4) Disconnect the amp from the L+R output and listen to the A output. You should hear the noise/tone mix being modulated in volume following the changes in the ADSR output. Turn the Pan control to full R and Toggle the ADSR/Cycle switch to ADSR. While still listening to the A output, adjust the Modulation Null Trimmer (R24 on the circuit board) to minimize any tone that you hear from the Amp.

6) Connect a second signal source to the CVa (Mod) input and listen to the A output for a balanced modulator sound while the relative frequencies of the two sources are varied. If you're not sure what Balanced Modulator should sound like there are .wav file samples at <http://paia.com/9710.htm>.

VCA section from 9710 illustration supplement, fig 7, schematic

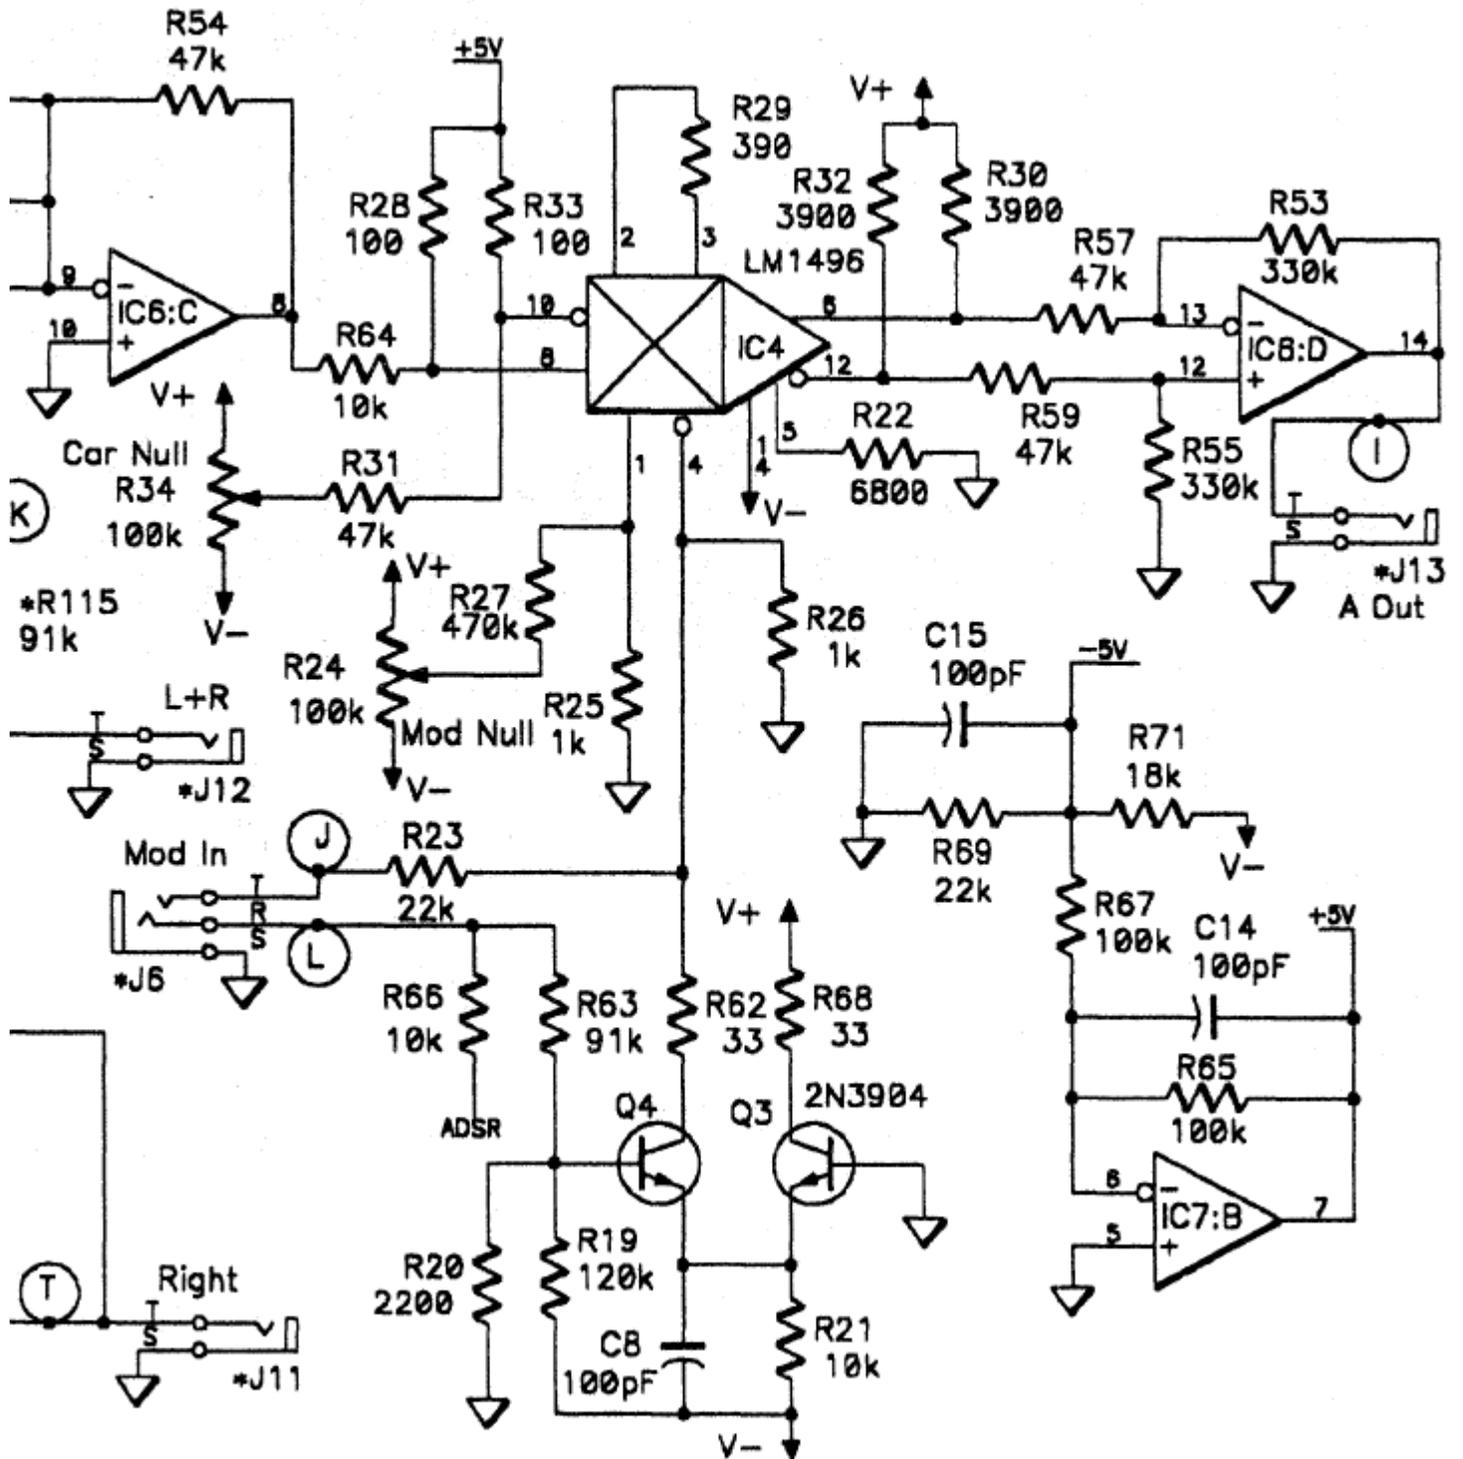
“In step #4 there was a slight tone with the Pan control at full "R"; when turning the "Modulation Null Trimmer" there was no discernible difference in the tone.

In step #6 there was a modulation sound, but the carriers were not of the same volume. The original carrier was much more dominant than the modulating signal.

There are remedial steps listed listed we are not sure if the step #6 is the expect behavior. Do we treat this as failing step #4 and step #6 or just step #4?”

The “trouble” checks following each Testing section are only very general. For example, for Test #4 check IC4, Q3, Q4 or associated parts, and, IC6 and Js 3 and 6 wiring – this simply implies verifying the parts are the ones specified and with the proper polarity, good soldering, etc. It is rare for parts to be the trouble due to defects, though they can fail if an accidental short-circuit occurs (ie board soldering comes in contact with metal while powered or probing for voltages results in contact between two nearby but separate circuits).

Specific to the trouble you describe, the R24 Modulation Trim not affecting the signal output in Test #4, check the middle, wiper terminal of the trim (also the end of R27 which connects with the wiper terminal) for a DC voltage which varies from negative 12VDC to positive 12VDC as the disc is adjusted from one extreme to the other.

This variable voltage should work to minimize the signal level at the VCA A output. It might not be eliminated, particularly if you are going into a sensitive input, but there should be a significant difference between the levels heard at the extremes and the dip which occurs at an intermediate setting of the trim corresponding to a VCA ADSR “off” control into the VCA A section. Looking at the one in P9700S here, it is set about mid-rotation for this condition.

If this checks to be OK, below are some other DCV readings in the VCA A section going sort of left to right from IC6c to IC6D according to the schematic. Set ADSR controls to 9:00 and modulator to Cycle.

IC6pin9 0V
IC6pin10 0V
IC6pin8 4.9

R34 wiper terminal (appx. calibrated setting) 4.4V

IC4pin10	5v
IC4pin8	5v
IC4pin2	-0.73
IC4pin3	-0.74 to -0.91
IC4pin1	-0.01 to -0.02
IC4pin4	-0.02 to -0.20
IC4pin14	-12
IC4pin5	-10.47
IC4pin6	6.33 to 6.35
IC4pin12	6.35 to 6.37

IC6pin13	4.75 to 4.90
IC6pin12	5.35 to 5.37
IC6pin14	-0.04 to 0.23

Test#6 has you checking for a complex tone which results from using one audio signal to modulate another audio signal. The difference you notice in the “mix” of the signals can be the result of something awry in Test#4, but it also is affected by the Carrier Trim setting which is set in the Calibration section on page 22 of the manual (advanced about two-thirds of the way on the unit here). DC voltage testing can be made for this trim, R34, in the previously described Modulation Trim tests.
